Well location, *WHU# 55*,
located as shown in the NW1/4
NW1/4 Section 12, T7S, R23E,
S.L.B.&M. Uintah County, Utah.

WALKER HOLLOW UNIT NO. 55
 Sec. 12, T7S, R23E
 Uintah County, Utah

FIELD NOTES SHEET

FROM: DISTRICT GEOLOGIST, SALT LAKE CITY, UTAH
TO: DISTRICT ENGINEER, O&G, SALT LAKE CITY, UTAH
SUBJECT: APD MINERAL EVALUATION REPORT

Date: 1-13-81

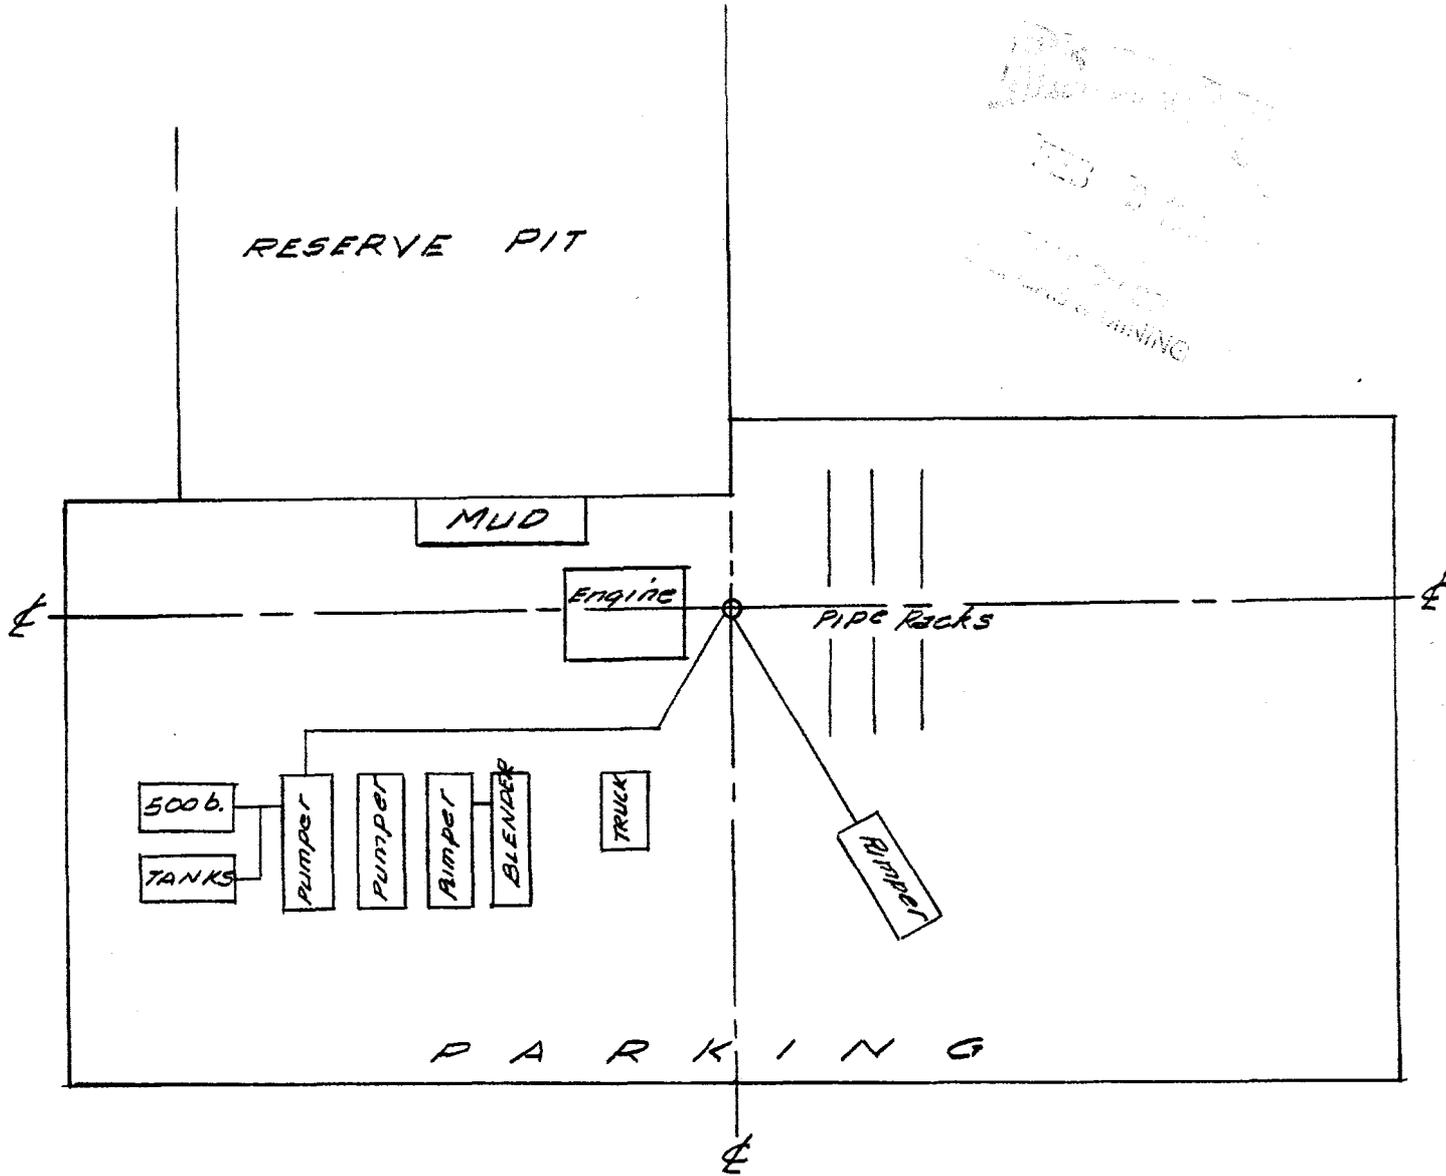
Redimensioned pit 20', 85', 175', 187' sides. Do deeper as needed. Line if necessary to maintain pit integrity (at the discretion of the geotr and P. E. Casella.

One good way to get a better set of plans might be to stick the geotr with a few locations like this one. He couldn't rotate it. The access road enters near a cut of 20⁺ feet and the pits were old deep and in a drainage. ~~But he said that he would like to see when we finally figured how they could possibly be built.~~ Moves south could improve the location. He probably should have considered that alternative more fully.

1. The reserve pits dimensions were changed so that the maximum

width will be 85 feet with the width being tapered down to approximately 20 feet near corner #4.

2. The top 2-4 inches of top soil will be gathered and stockpiled between reference corners #1 and #9.
